**Predevelopment Plan Review
Comments to Applicant**

Project Number: PPR2018-00005 **Date:** May 22, 2018

Project Address: 150 E. Colorado Boulevard

Project Description: Predevelopment Plan Review for the construction of a 196,132 square-foot, eight story mixed-use development, consisting of 88-100 residential units, 50,850 square feet of nonresidential floor area (restaurant, retail, office), and 400 parking spaces.

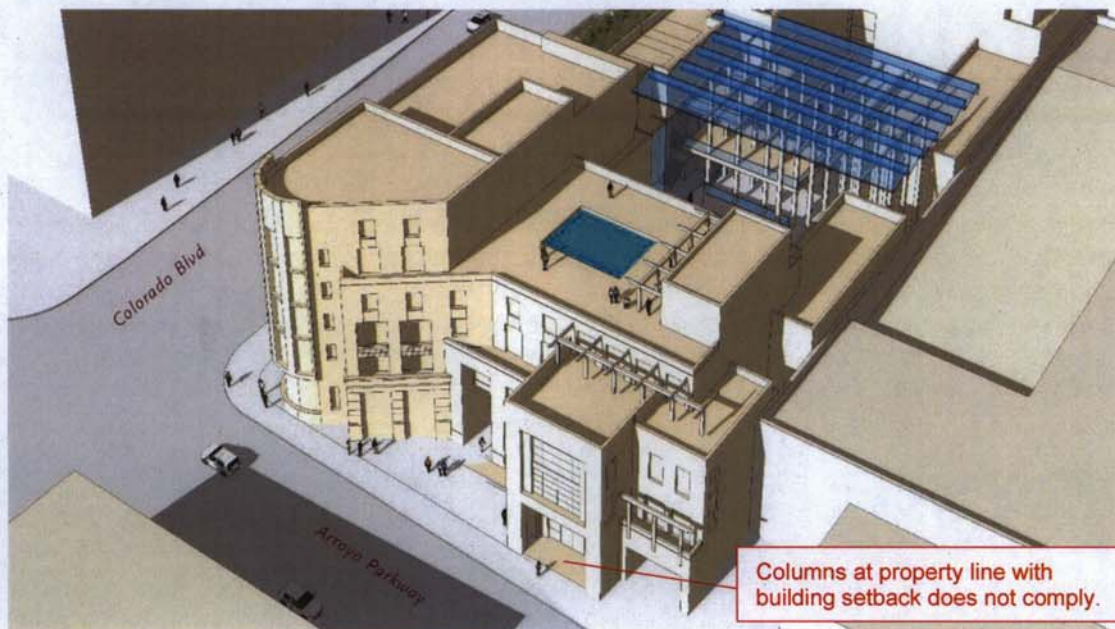
The setback diagram and aerial views indicate portions of the building along Arroyo Parkway, Colorado Boulevard, and Marengo Avenue are not built to the property line. These areas do not comply and should be revised accordingly such that the improvements are brought forward to the property line. In addition, aerial views suggest individual entries to the building are setback from the property line while the columns supporting the upper floors are proposed at the property line. This scenario does not comply with the requirement to build to the property line. Similarly, the floors above do not comply with setback requirements and should be revised accordingly.

Alternatively, should the applicant pursue setback exceptions specified in 17.30.050.A, the burden is on the applicant to provide detailed information substantiating applicability as part of any design review and/or land use entitlement application. This information and/or narrative shall address each component that seeks a setback exception, as opposed to a general description for the entire project. Otherwise, a strict application of the setback requirements applies.

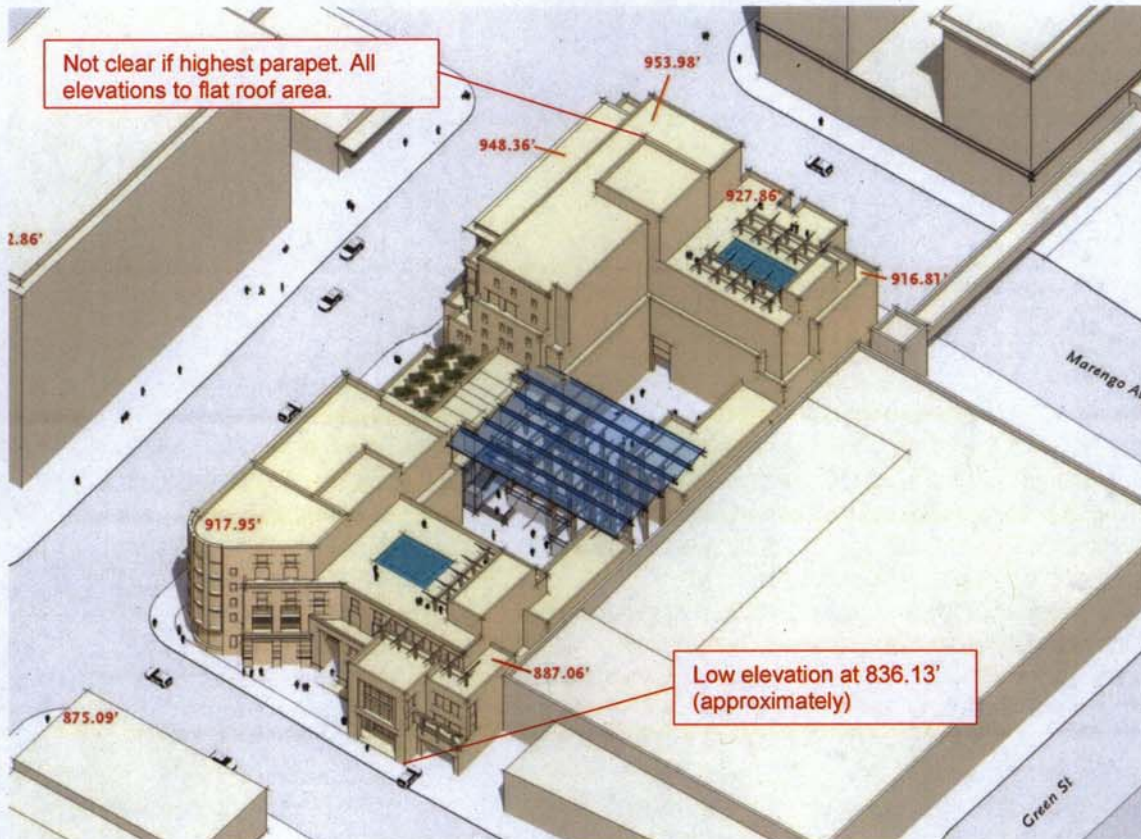
The building massing and height envelope exhibit suggests that more than 30 percent of the building footprint exceeds a maximum height of 75 feet, and that the proposal does not comply with height averaging. In addition, the building height comparison diagram references a high elevation of 953.98 feet at the eastern side of the site. At the western side of the site, where the lot is at its lowest point, the survey references an elevation of 836.13 feet at a location that approximately coincides with the exterior wall of the structure. This difference in elevation represents approximately 117.85 feet (953.98' – 836.13'). Further, it is unclear whether the elevations on the height comparison diagram account for the parapet shown around the roof on aerial views, as that would be the

highest point. The project height proposed requires approval of a Variance because it does not comply with the maximum allowed height.

Site Plan

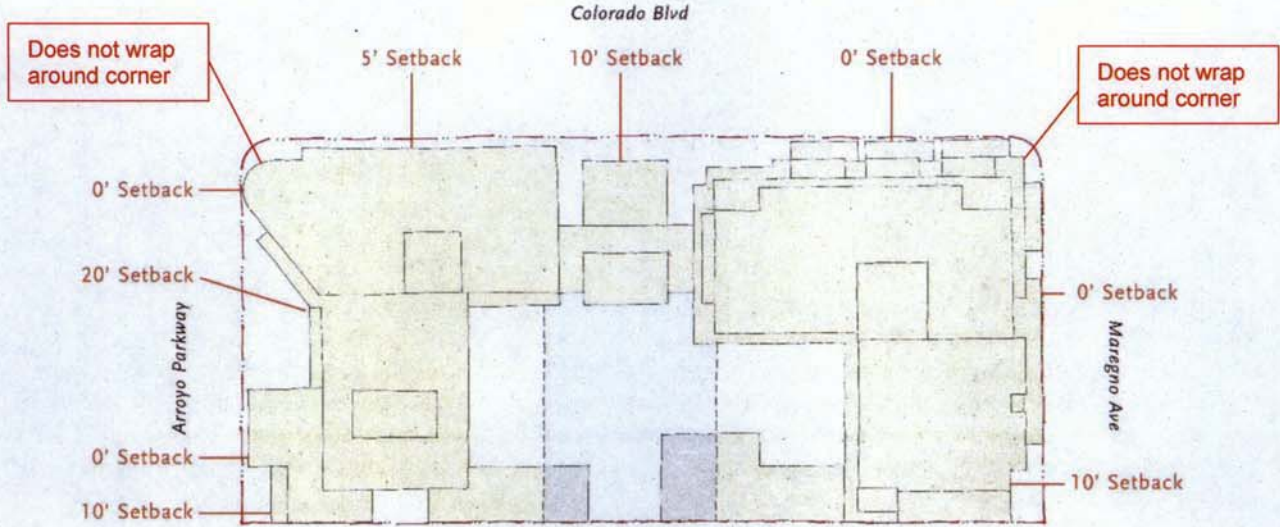
The ground floor plan does not comply with the requirement that the commercial space turn and wrap around the corner. In addition, plans do not provide enough information to determine whether the minimum 50-foot depth is provided throughout all frontages. Variations in the depths may be less than 50 feet deep. Plans should provide a level of detail that demonstrates compliance with these standards where applicable.
